UNITED STATES PATENT AND TRADEMARK OFFICE

APPLICATION NO.	FILING DATE	FIRST NAMED INVENTOR	ATTORNEY DOCKET NO.	CONFIRMATION NO.
10/670,540	09/24/2003	Alexander W. Harkness	NSD2003-006	5475

Office Action Summary	Application No. 10/670,540	Applicant(s) HARKNESS ET AL.	
	Examiner Daniel L. Greene Jr.	Art Unit 3663

DETAILED ACTION

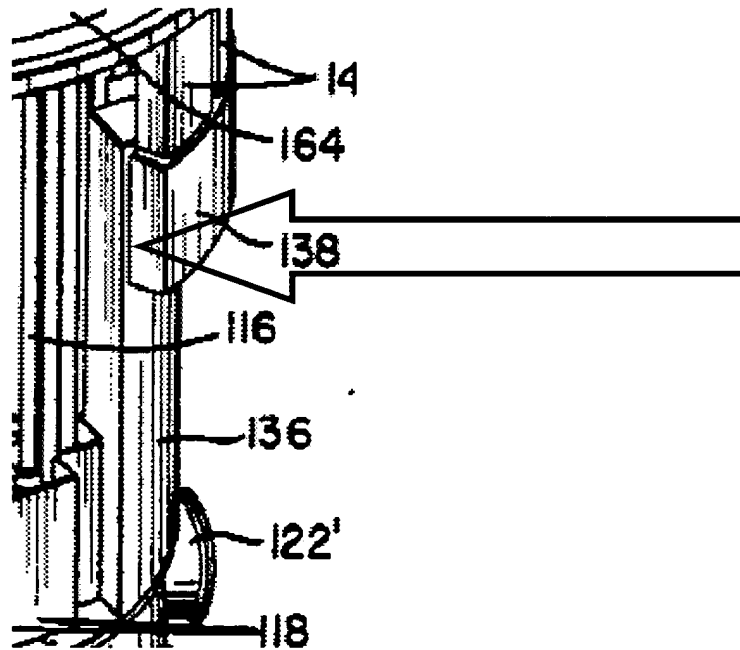
Additionally it is pointed out that MPEP 2144 states that making separable, rearrangement of parts (such as interspersing the ducts within the CRDMs), duplication of parts and/or changing the shape does not make an invention patentably distinct. See *In re Dulberg*, 289 F.2d 522, 523, 129 USPQ 348, 349 (CCPA 1961), *In re Japikse*, 181 F.2d 1019 86 USPQ 70 (CCPA 1950) and *In re Kuhle*, 526 F.2d 553, 188 USPQ 7 (CCPA 1975), *In re Harza*, 274 F.2d 669, 124 USPQ 378 (CCPA 1960), *In re Dailey*, 357 F.2d 669, 149 USPQ 47 (CCPA 1966)

Claim 6 is further disclosed in, for example, column 7 lines 26-30, wherein it is understood that rearranging the air ducts to be internal, vice external is an obvious variant performing the same functions. Figure 2 indicates that the upper leg member is attached by both a nut assembly and a clevis assembly, Malandra further discloses the use of clevis assemblies in, for example column 6 lines 6-14 and 37-45. Further, Malandra column 9 lines 17-25 set forth the condition

wherein the upper plenum will be supported by the upper leg members (156) with the seismic support supported by the lower leg members (column 6 lines 20-24).

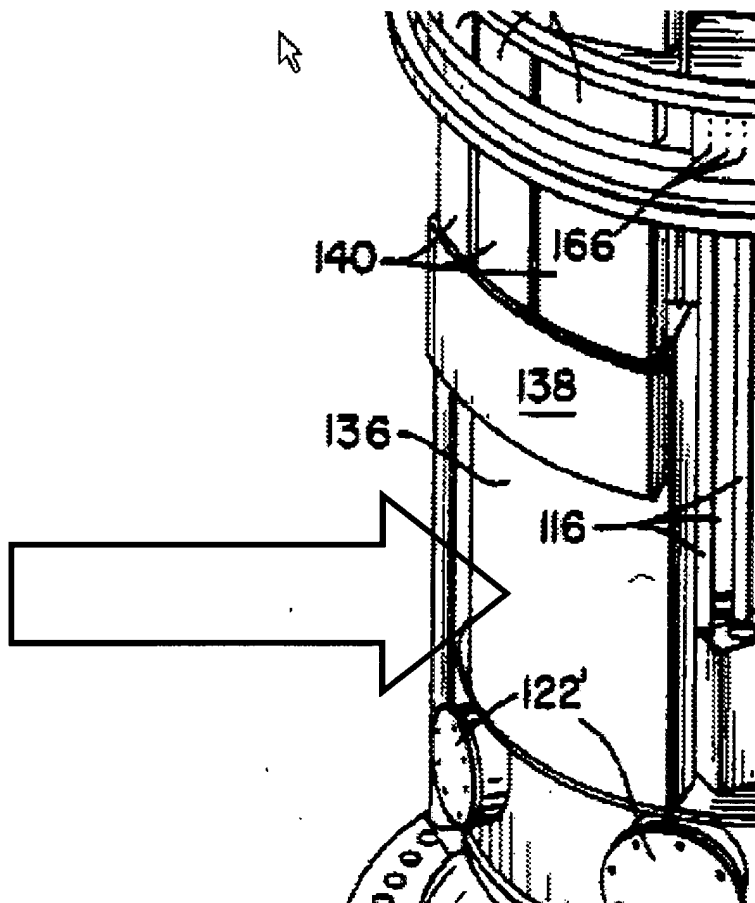
Claim 11 is disclosed in, for example Figure 2 wherein the ducts have an L shape in the vertical direction where item (136) joins with item (138) wherein it is understood that the term "duct" reads on the combination of all the parts that make up said duct.

Claim 12 is disclosed in, for example Figure 2 wherein the ducts have a rectangular shape when viewed from the side as they extend vertically from the lower air manifold to the fans.

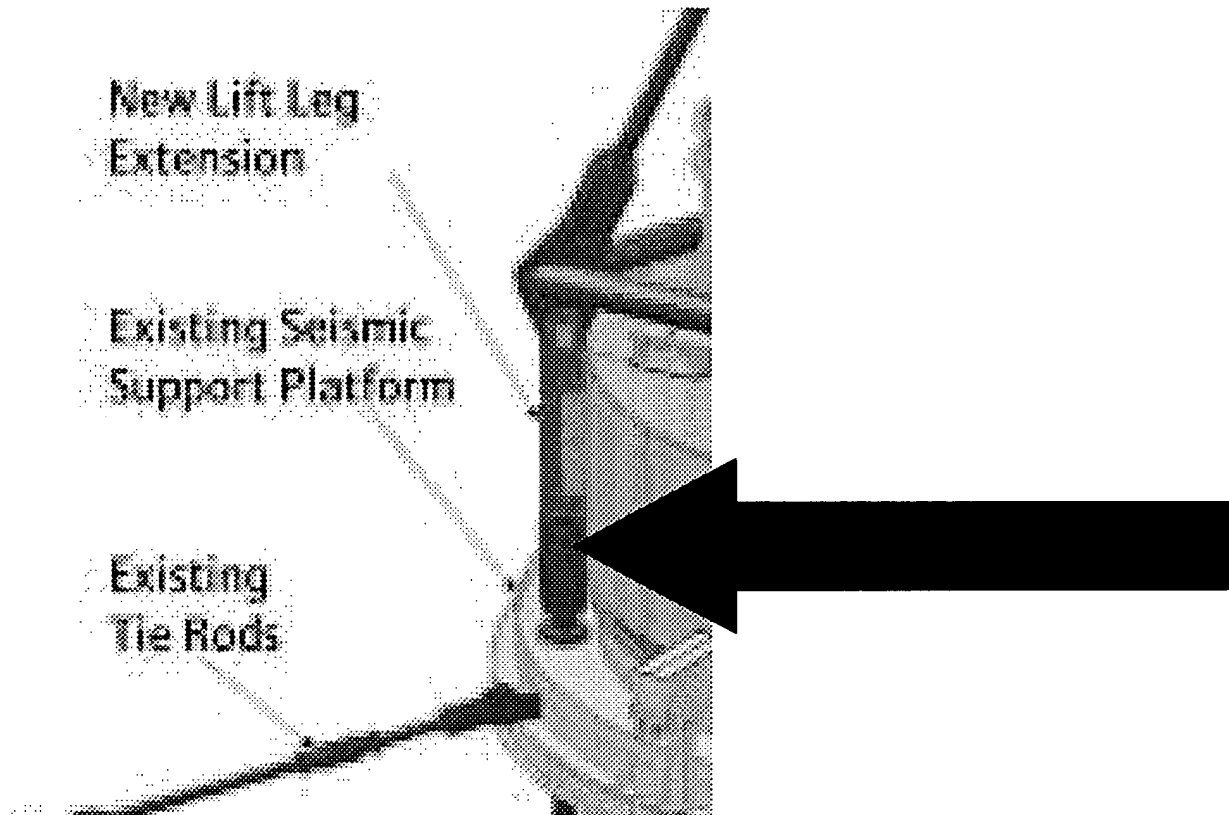
a. SHA discloses applicant's invention substantially as claimed including the missile shield being totally within the upper plenum. The limitation "internal duct"

as broadly interpreted reads on the passageways within the “new upper shroud” that allow the air to flow there through.

b. If applicant is of the opinion that the internal air flow passageways do not read on the limitation “internal duct” then it would have been obvious to replace the upper shroud with internal ducts as Mazure et al. column 3 lines 1-25 clearly states “the function of the ductwork...is to afford a means of funneling to the reactor vessel the cooling required in the course of conduct of the operation of the nuclear reactor housed within the reactor vessel”. Clearly if it was determined that specific areas of the reactor vessel required additional cooling that additional ductwork/fans or redirection of current ductwork would be warranted.
